ARCHITECT'S SUPPLEMENTAL INSTRUCTION NO. 7

DATE: April 08, 2024 PROJECT NO: 230117

RE: Streets of West Pryor – Lot 5 Core & Shell

SHEET NUMBER
ME-202

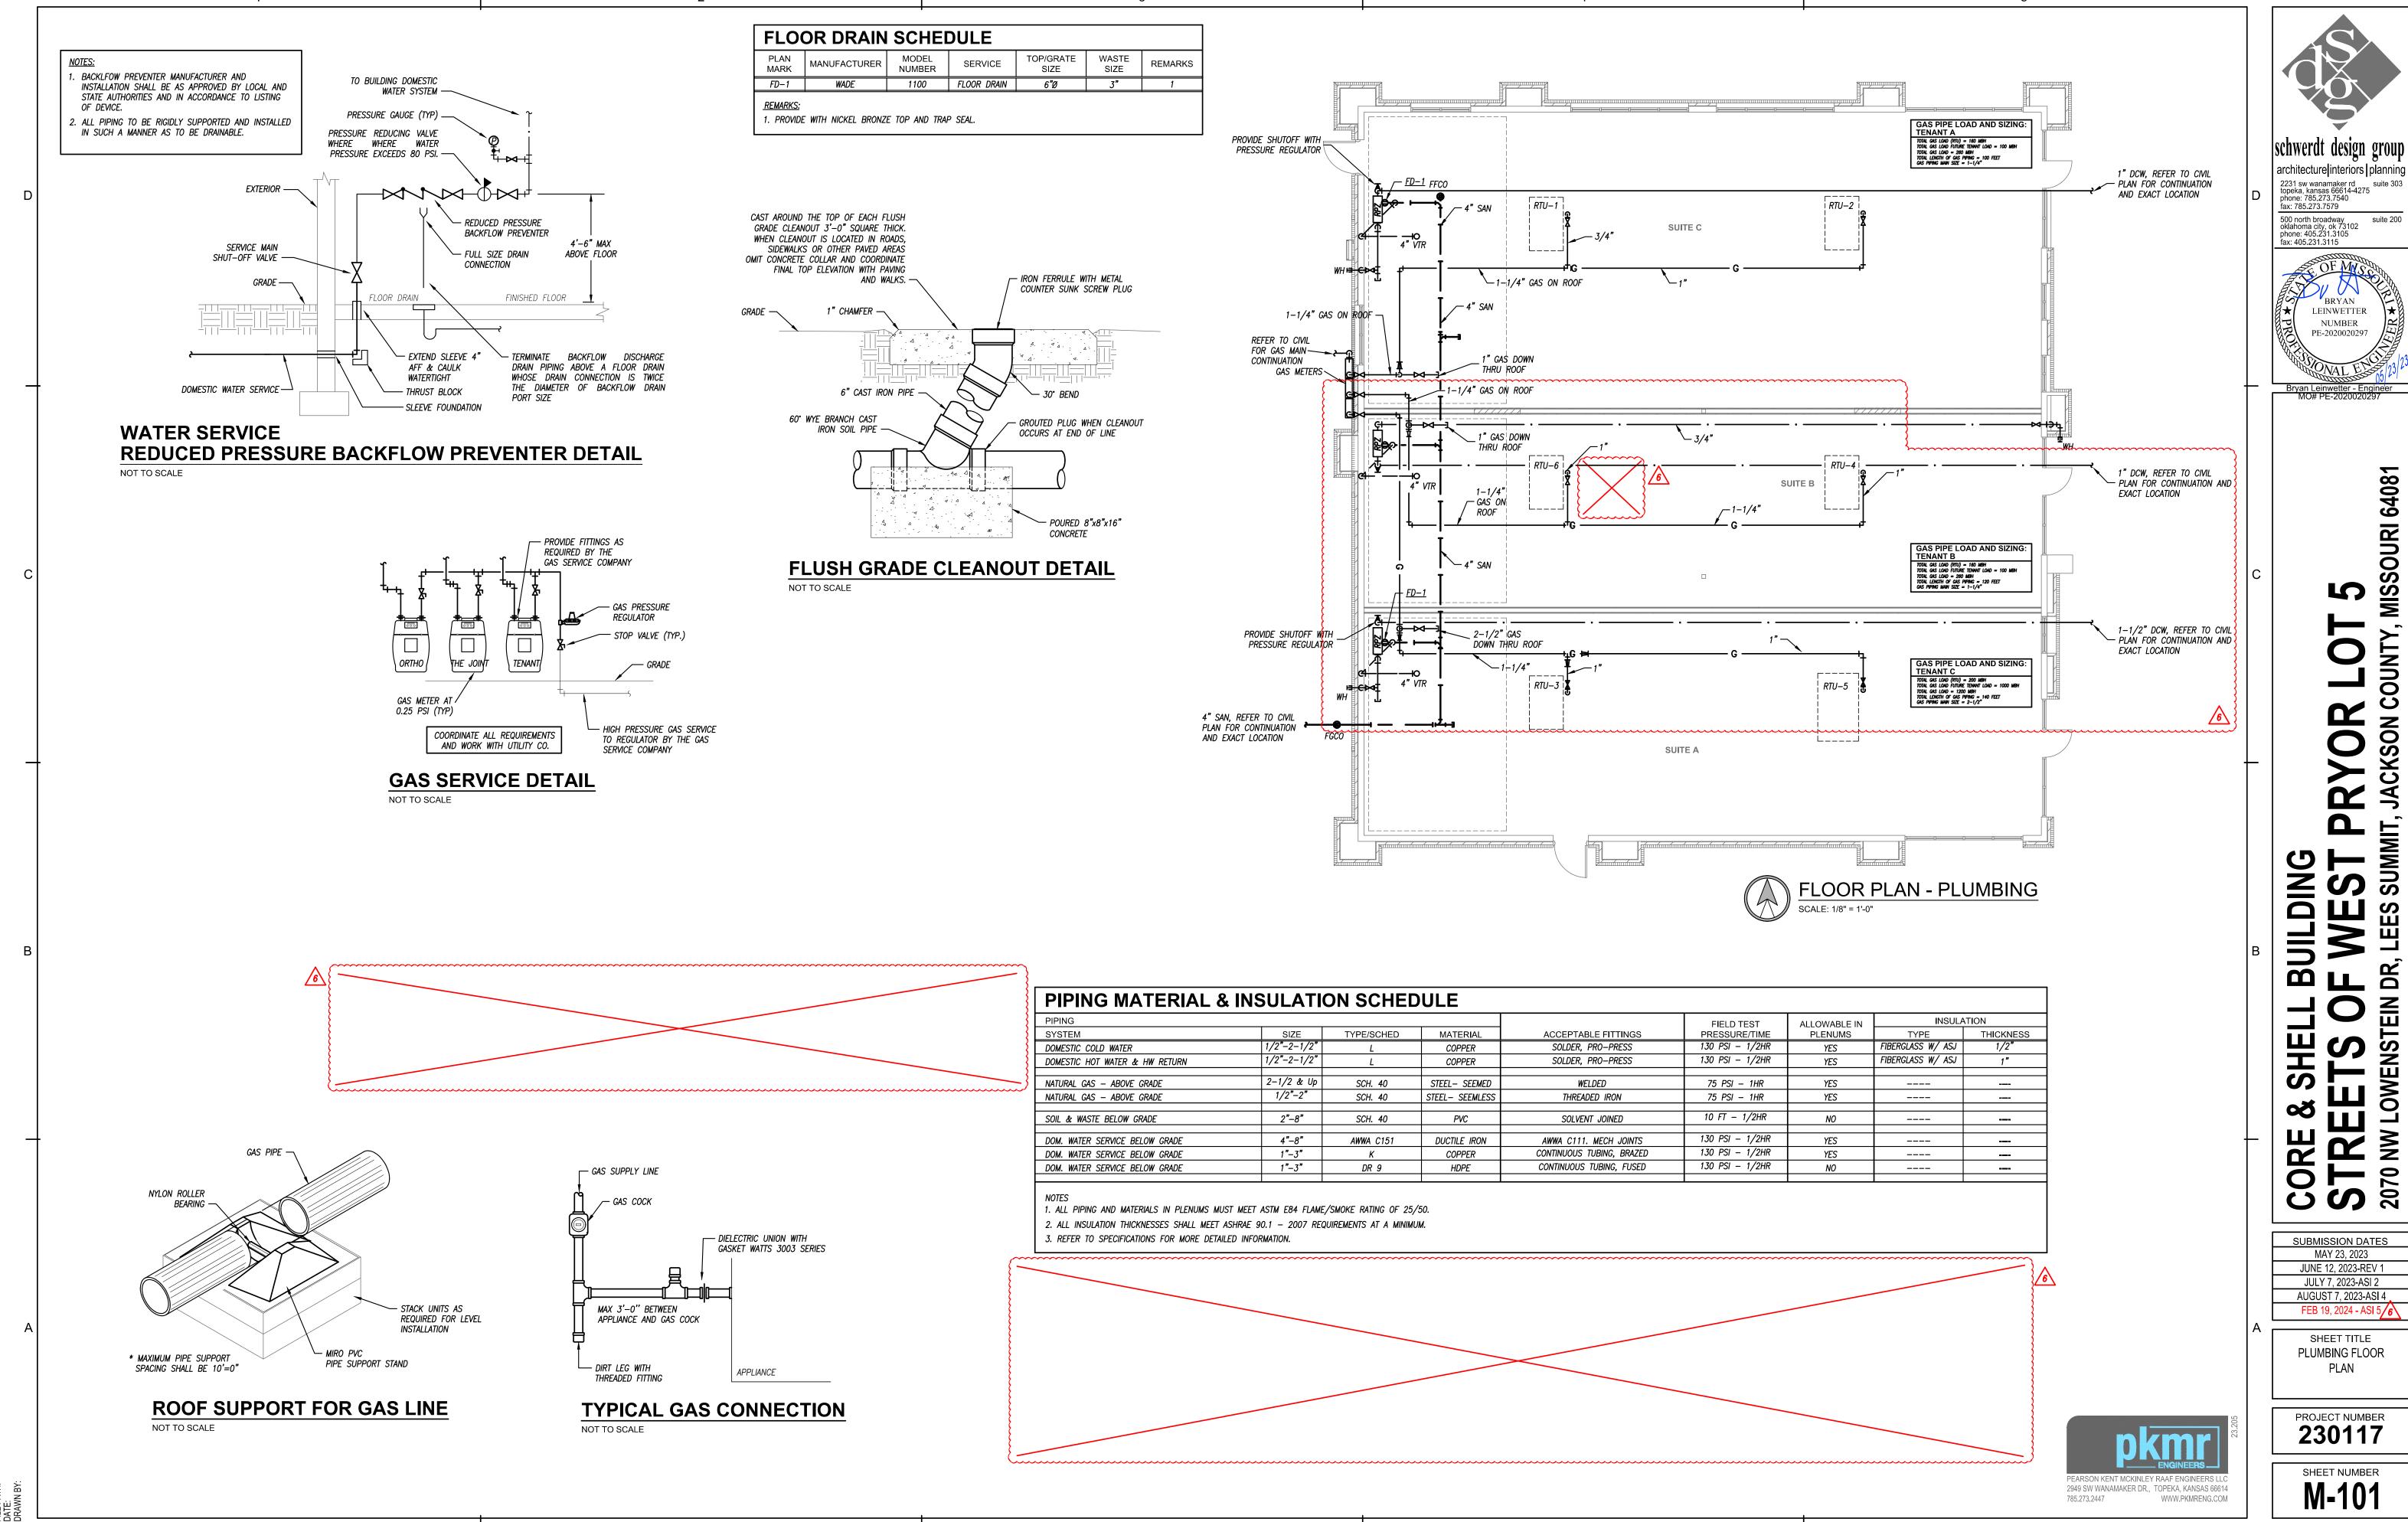
- MEP-1 Sheet ME-201 Updates to Light Fixture Schedule to show "C" fixtures on exterior. MEP-1.A Movement of Light Poles.
- MEP-2 Sheet ME-202 Updated placement of exterior utilities
- MEP-3 Sheet M-101 Swapping the respective placement of RTU 3 and RTU 4 for each other. MEP-3.A Rotation of RTU units
- MEP-4 Sheet M-201 Rotation of RTU units
- MEP-5 Sheet E-101 Swapping the respective placement of RTU 3 and RTU 4 for each other.

SHEET NUMBER M-101

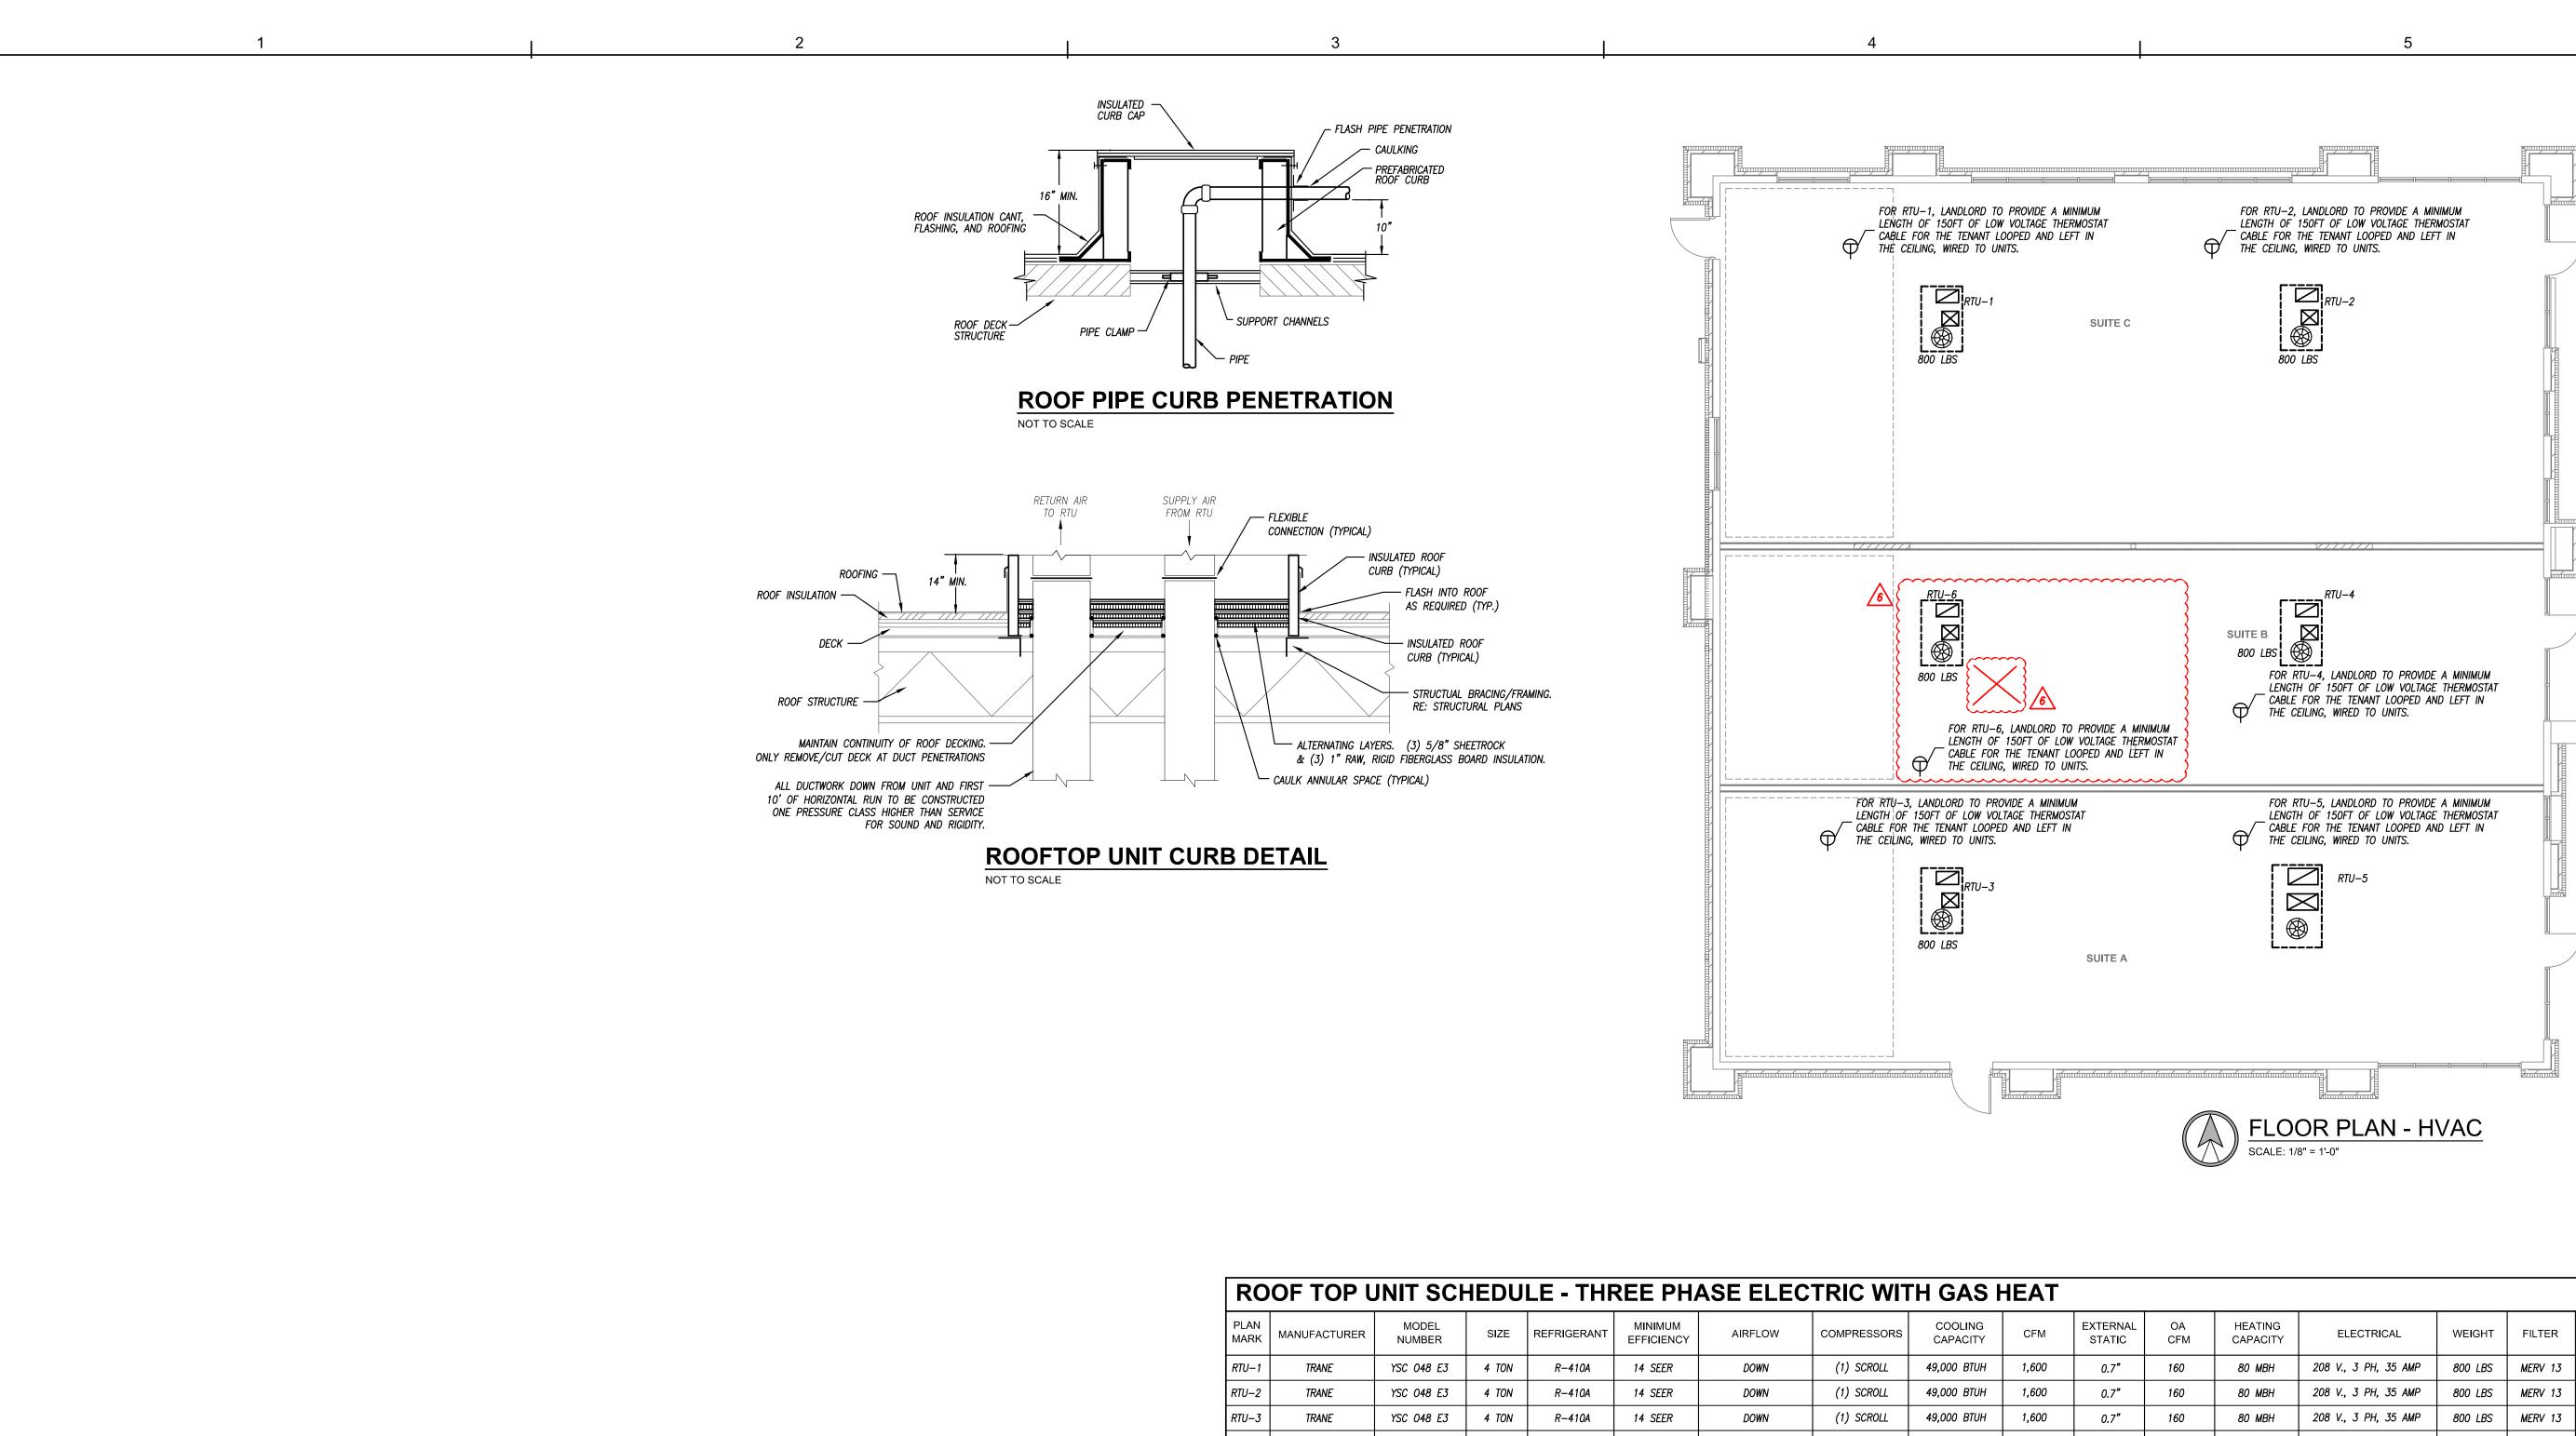
MEP-1 Sheet M-101 – Restroom removed; RTU added to service enlarged Tenant Suite B space.

MEP-1.A Water heater and Plumbing Fixture schedules removed.

SHEET TITLE POWER FLOOR PLAN

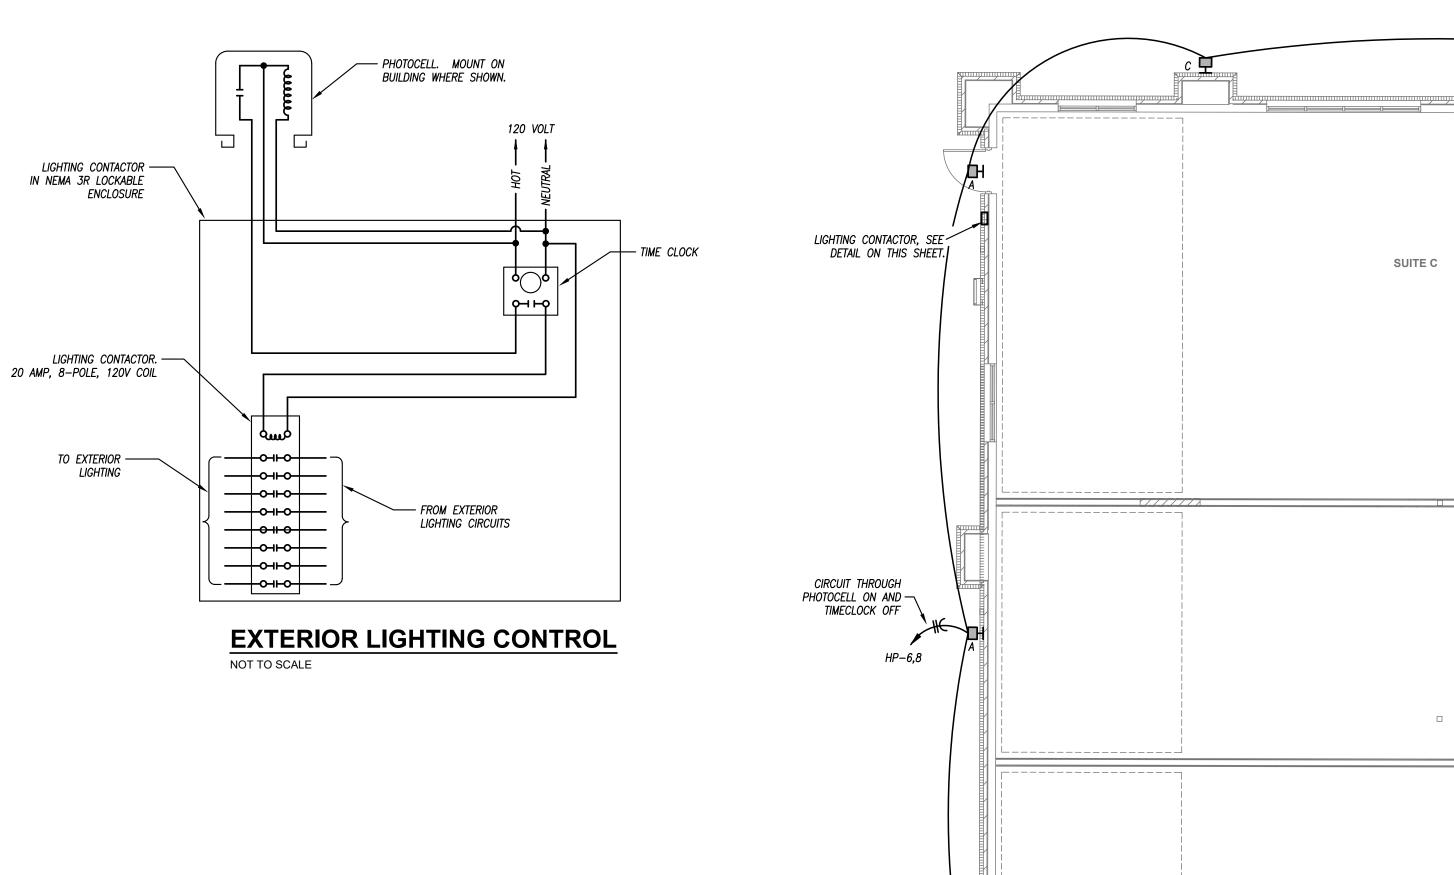
MEP-1 Sheet E-101 – Electrical Riser Diagram updated to two-hundred amp system.

MEP-3 Sheet E-101 – Restroom removed; RTU added to service enlarged Tenant Suite B space.

MEP-3.A Panelboard schedule updated.

MEP-3.B Electrical riser diagram updated with 400A panels.

MEP-3.C Electrical Floor Plan – Power updated for tenant suites A & B.

SUBMISSION DATES
JUNE 12, 2023-REV 1 JULY 7, 2023-ASI 2 AUGUST 7, 2023-ASI 4 FEB 19, 2024 - ASI 5 MARCH 13, 2024 - ASI 6 / 7 SHEET TITLE LIGHTING FLOOR PLAN PROJECT NUMBER **230117** SHEET NUMBER

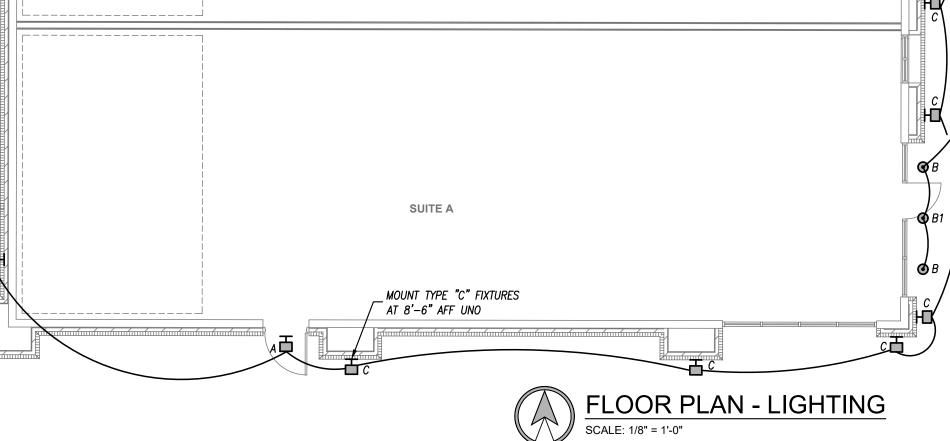
MEP-2 Sheet E-201 – Double-Section Panelboard Schedule updated for two-hundred amp system.

MEP-4 Sheet E-201 – Floor Plan – Lighting updated to three tenant suites A,B & C respectively and Double-Section Panelboard Schedule added to sheet.
